DECISION OF THE ENDURANCE COMMITTEE

To: Teams Manufacturers
Decision N°: 13-D0006-LMP1-HY
Date: 03/04/2013
Re: Braking zones for the 6 HOURS OF SILVERSTONE

WEC_2013_01_Silverstone_CircuitMap.png

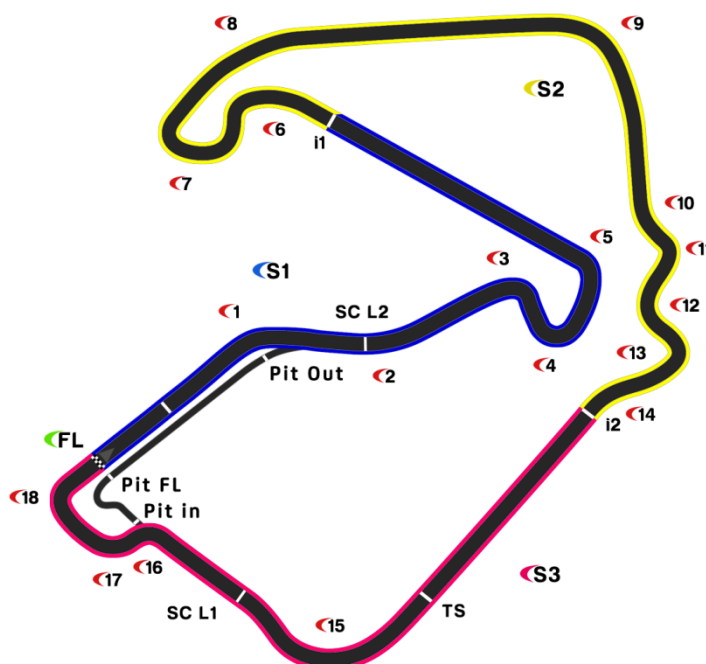
Simulation have conducted to predetermination of the following braking zones for the 6 HOURS OF SILVERSTONE (4 "braking zones") :

- Braking zone # 1 : Turn # 3
- Braking zone # 2 : Turn # 6
- Braking zone # 3 : Turn # 15
- Braking zone # 4 : Turn # 16

The entry of each zone will be considered at the 50m board before the curve.
